SAFETY EVALUATION BY THE OFFICE OF NUCLEAR REACTOR REGULATION
SUPPORTING AMENDMENT NO. 64 TO FACILITY OPERATING LICENSE NO. DPR-33

AMENDMENT NO. 60 TO FACILITY OPERATING LICENSE NO. DPR-52

BROWNS FERRY NUCLEAR PLANT, UNIT NOS. 1 AND 2

DOCKET NOS. 50-259 AND 50-260

Residual Heat Removal System, Unit
Cross Connections and Standby Coolant Supply

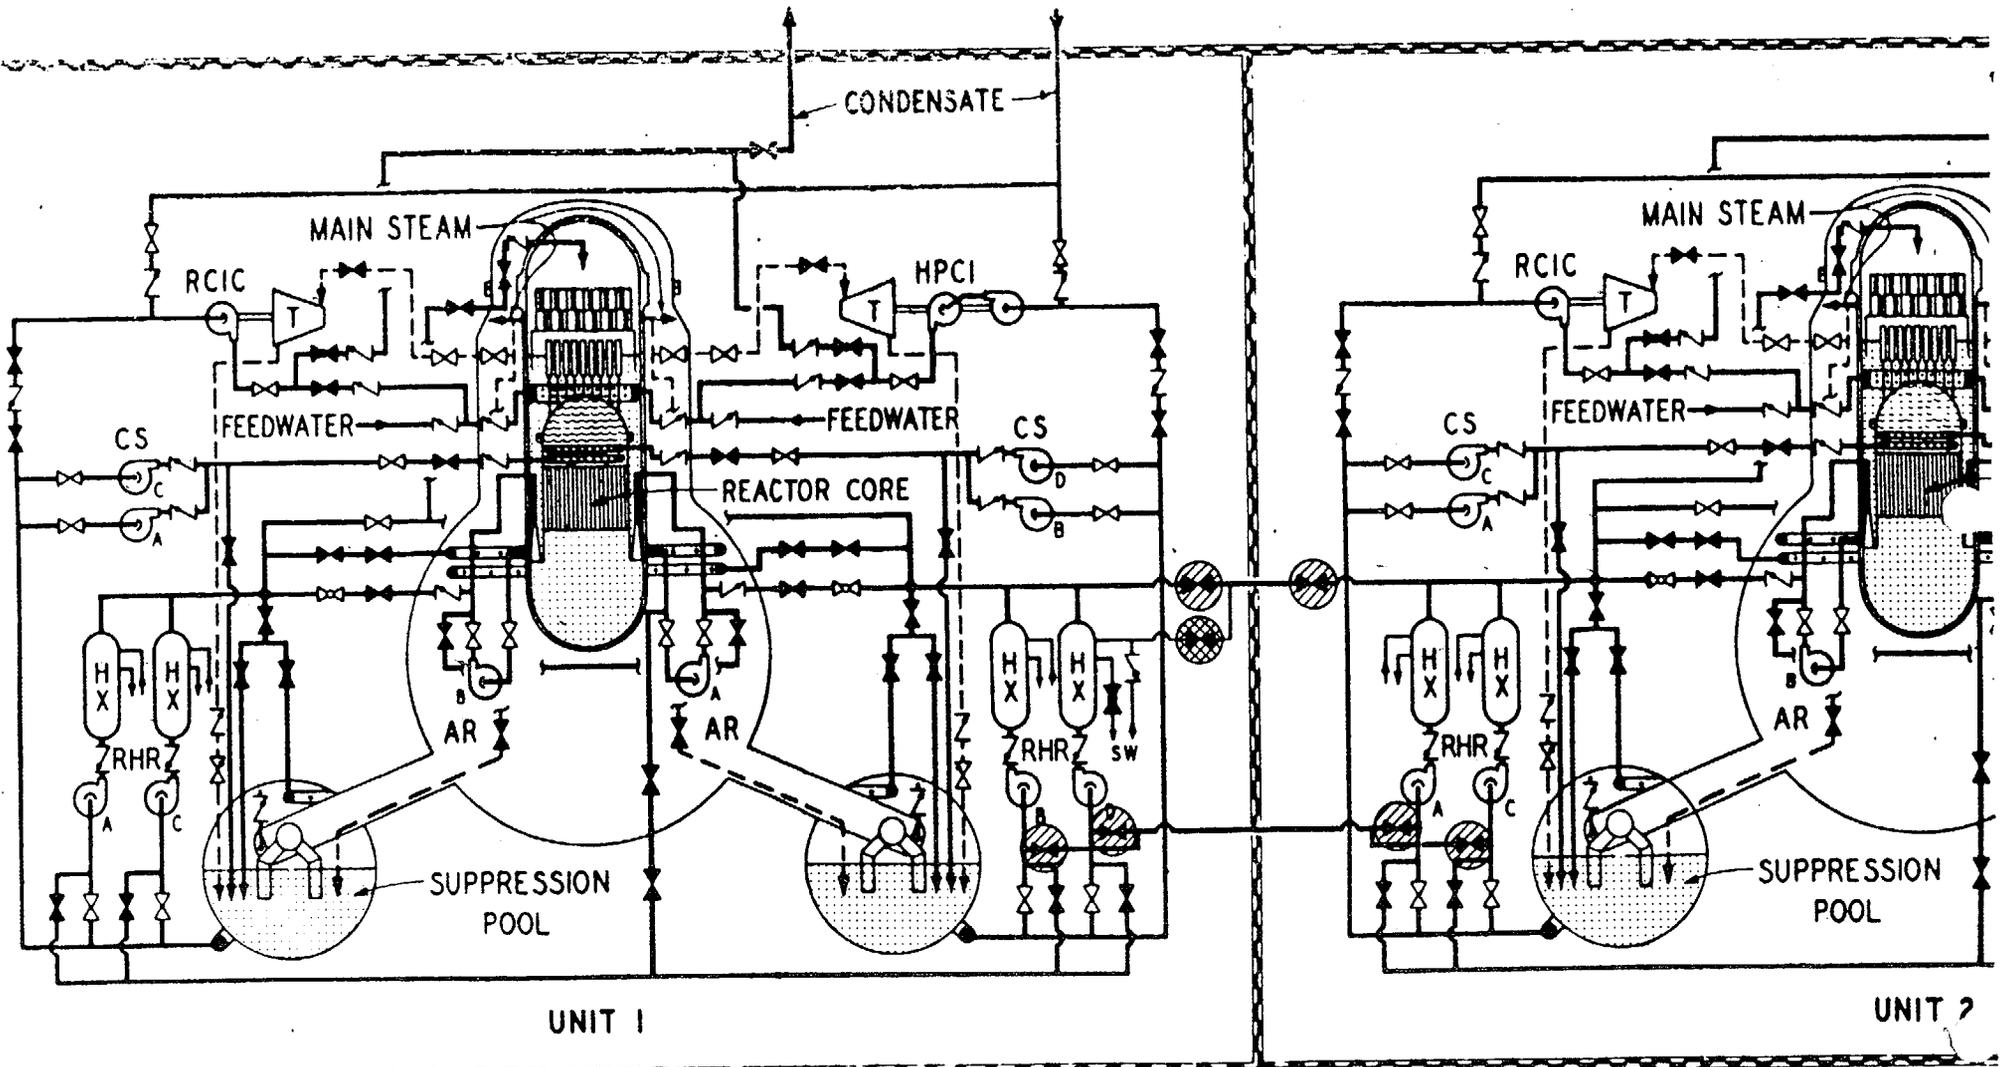
As noted in the previous safety evaluation, the RHR pump suction and heat exchanger discharge lines of one loop in Unit 1 are cross-connected to the pump suction and heat exchanger discharge lines of one RHR loop in Unit 2. Units 2 and 3 systems are cross-connected in a similar manner. This arrangement is shown in the attached figure for Units 1 and 2. The cross-connection valves are those in the lined or cross-hatched circles. The cross-hatched valve permits RHRSW (river water) from the IDRHR heat exchanger to be added to the RHR system (primary coolant) as a last-ditch emergency if all the "clean" water sources of cooling water in Units 1 and 2 have been lost (condensate, suppression pool, etc.) and the normal service water makeup in the unit in trouble is not available. The present Technical Specifications do not provide any period of time for the RHRSW cross-connection to be out of service, which in turn does not allow the associated RHR heat exchangers and RHRSW pumps to be out of service for maintenance - even though there is considerable redundancy in the RHR systems and the present Technical Specifications permit the RHR cross-flow connections to be out-of-service for up to 10 days. We conclude, as we did in Amendment No. 34, that the proposed Technical Specification change to allow a 10 day outage time for the RHRSW cross-flow connection between units is acceptable and that the overall reduction in plant safety margin is insignificant.
